44725 GRAND RIVER (DAMAS BUILDING) PARKING EXPANSION JSP26-07

Consideration at the request of Versa Real Estate for approval of the Preliminary Site Plan. The property is located east of Taft Road and south of Grand River Avenue (Section 15). The applicant proposes site improvements including the addition of 20 parking spaces.

Review Date: May 26, 2026
Review Type: Revised Preliminary Site Plan
Project Name: **JSP26-07 Damas Building Parking Lot Expansion** (44725 Grand River)
Plan Date: April 29, 2026
Prepared By: Diana Shanahan, Planner dshanahan@cityofnovi.org (248) 347-0483

Figure 1. City of Novi Regulated Woodland and Wetland Map
Site Boundary is outlined in red
Approximate Woodlands are shown in green
Approximate Wetlands are shown in Blue

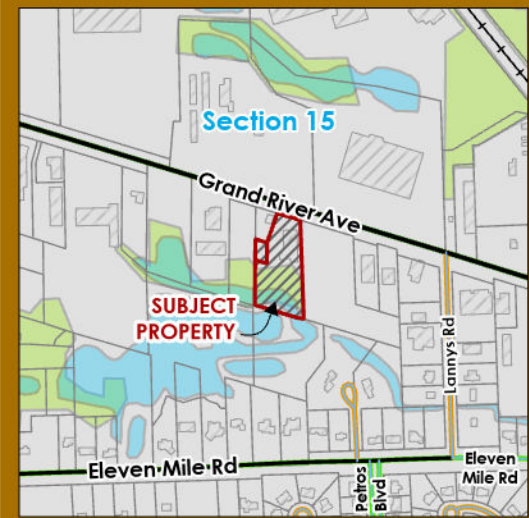
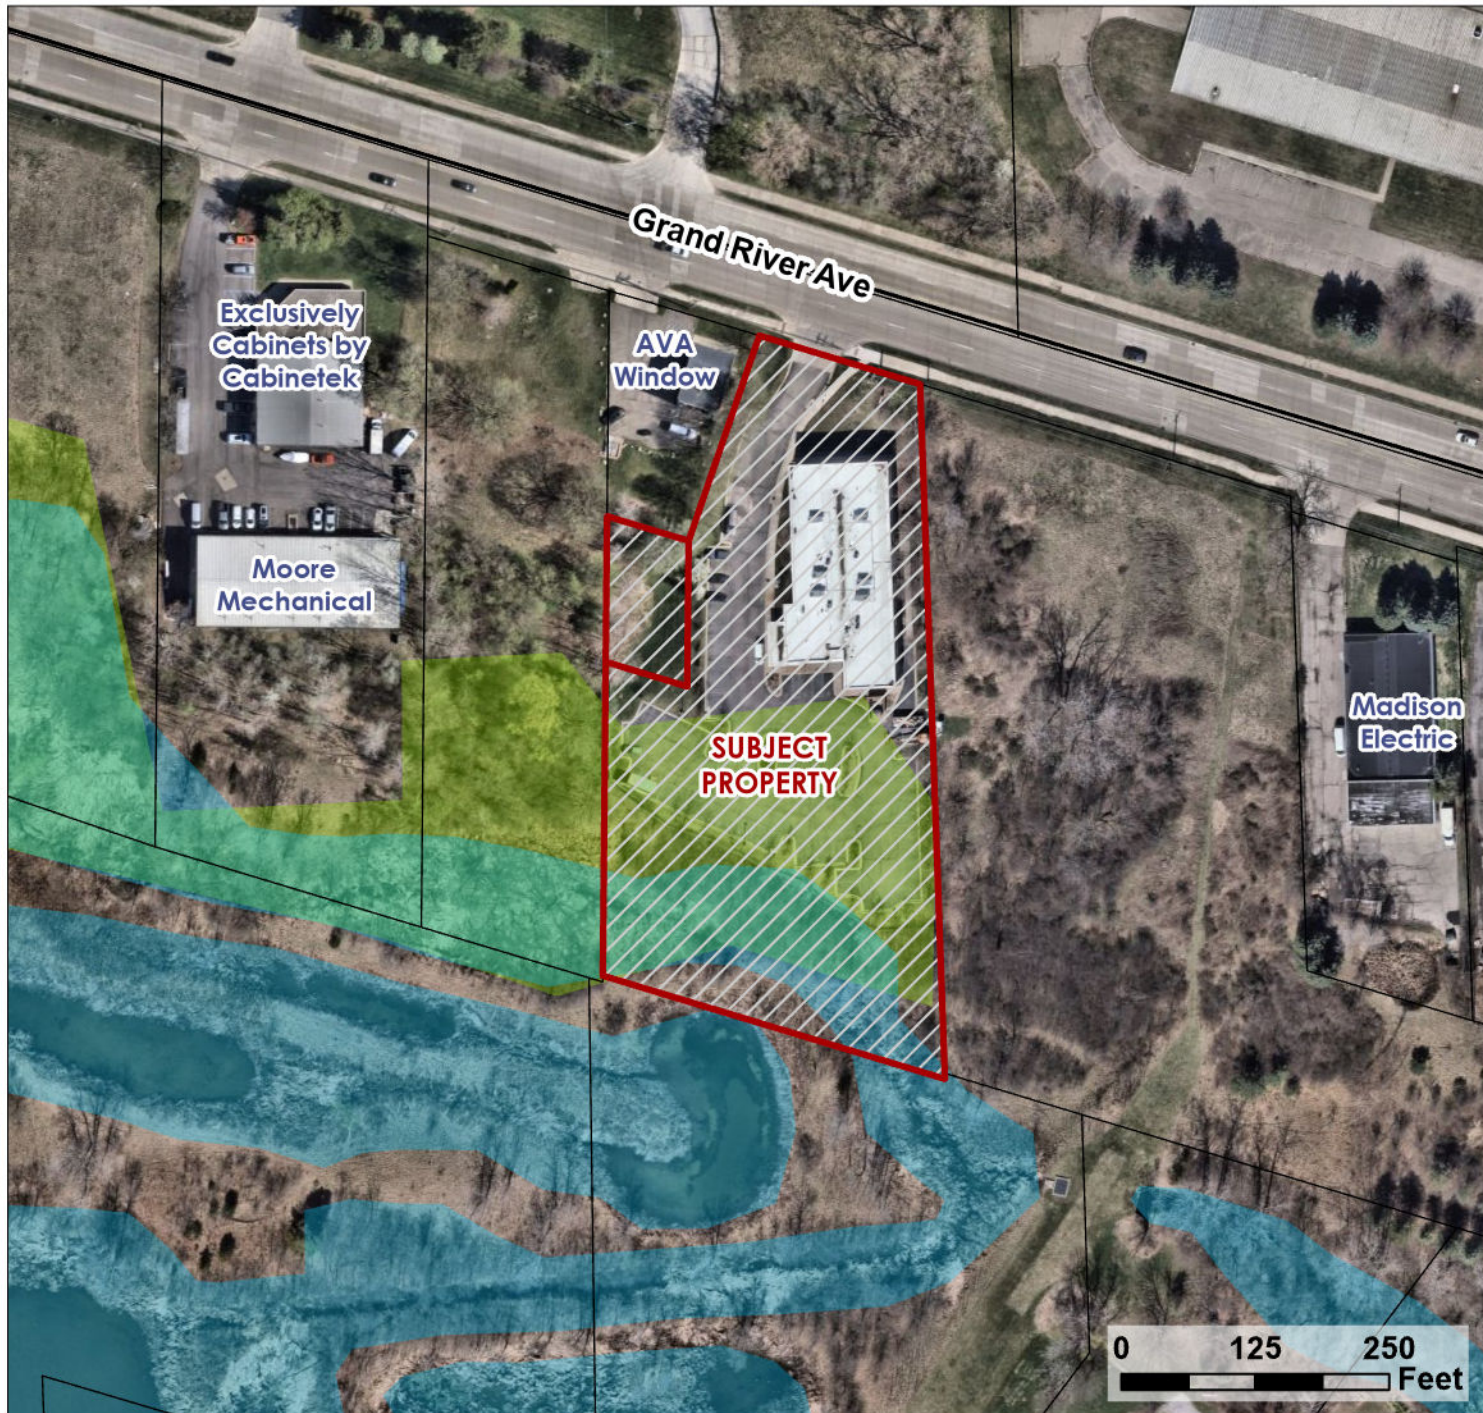
Based on a site review conducted on May 15, 2026, Merjent agrees with the wetland boundaries as depicted on the site plan and provided wetland delineation report (**Figure 1**). The wetland south of the proposed Project extends to the southern retaining wall and is dominated by hairy sedge (*Carex lacustris*) and sandbar willow (*Salix exigua/interior*). Photographs from the site visit are included in **Attachment A**. Upon review of published resources, the Site appears to contain or immediately borders:

- City-regulated wetlands, as identified on the City of Novi interactive map website. Note that both wetland and property limits depicted on the City’s map are considered approximations (**Figure 1**).
- Wetlands that are regulated by the Michigan Department of Environment, Great Lakes, and Energy (EGLE).
- Wetlands as identified on National Wetland Inventory (NWI) and Michigan Resource Inventory System (MIRIS) maps, as identified on the EGLE Wetlands Viewer interactive map website (provided in pre-app review). NWI and MIRIS wetlands are identified by the associated governmental bodies’ interpretation of topographic data and aerial photographs.
- Hydric (wetland) soil as mapped by the U.S. Department of Agriculture, Natural Resources Conservation Service, as identified on the EGLE Wetlands Viewer interactive map website (provided in pre-app review).

DESIGNED BY: RMS
 DRAWN BY: JPD
 SCALE: 0 10 20
 SCALE: 1"=20'
 SHEET NO. 9

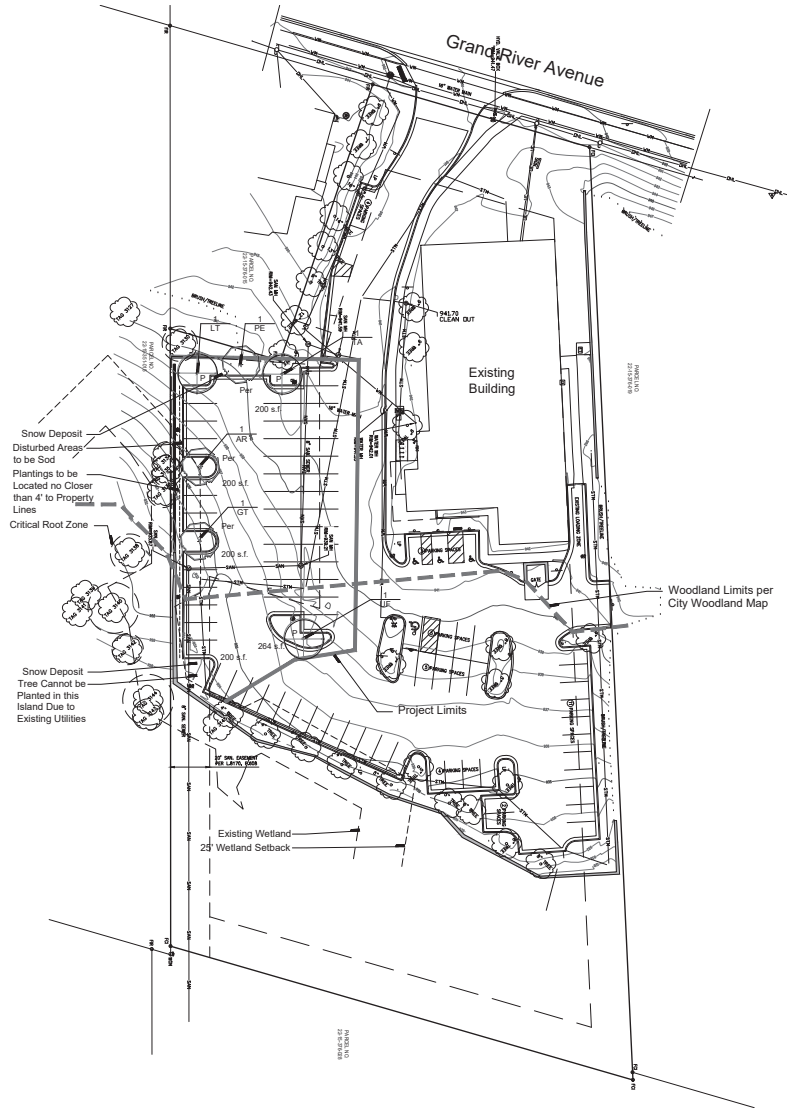
- The revised site plans depict the 25-foot wetland setback on Sheet 9 (Impervious Area Plan). A portion of the proposed parking lot expansion encroaches within the 25-foot wetland setback. The existing parking lot and retaining wall are also within the 25-foot setback.
